**Re: Construction Storm Water Inspection at Liberty Union High School
Fairfield County
Permit Number 4GC03102*AG**

This letter is written in follow-up to a construction storm water inspection by Stephen Riley and Megan Reising, of the Ohio EPA, conducted at Liberty Union High School located at 500 Washington Street on July 29, 2010. The purpose of the inspection was to evaluate compliance with the General Storm Water Permit Associated with Construction Activities. It appeared during the inspection that construction activity is completed for this site. A Notice of Termination will be required provided the following requirements are met.

Figure 2: Lack of controls on stock pile in rear of school

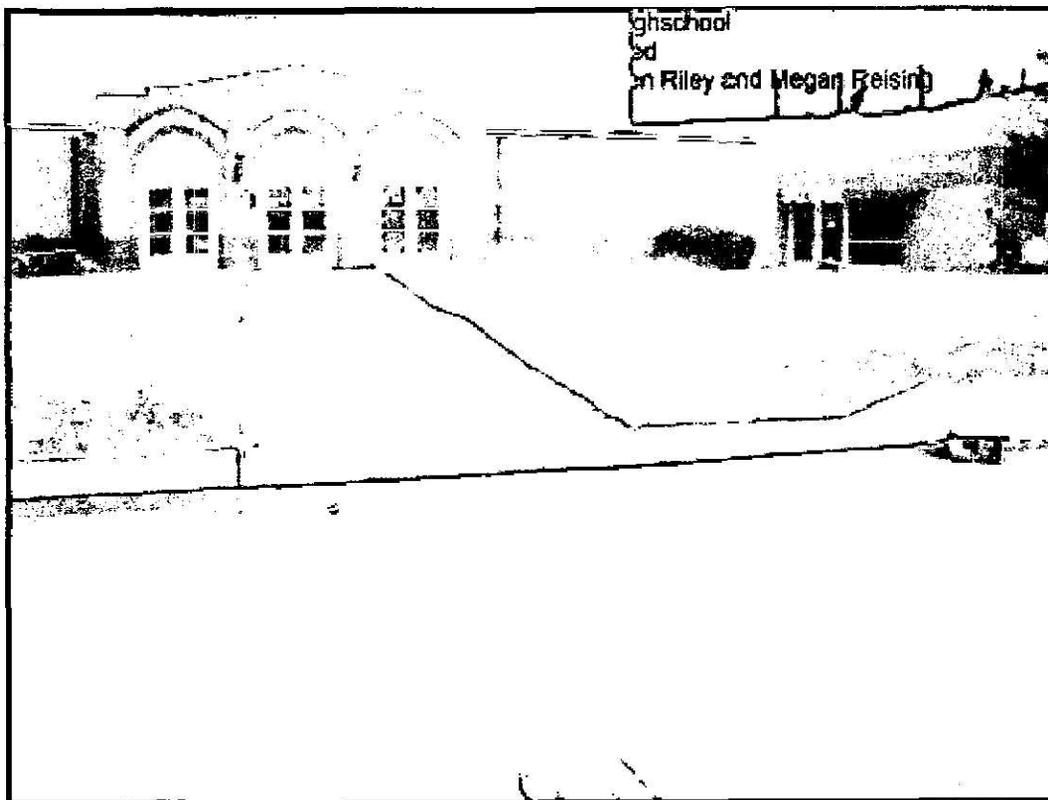
- During the inspection our staff noticed barren areas in the front and the rear of the school (Figure 1 and 2). Be aware the General Permit states that all barren areas which remain idle in excess of 21 days must be protected from erosion within seven days of the last earth disturbing activities. In addition, erosion protection must be implemented for all areas of final grade within seven (7) days.
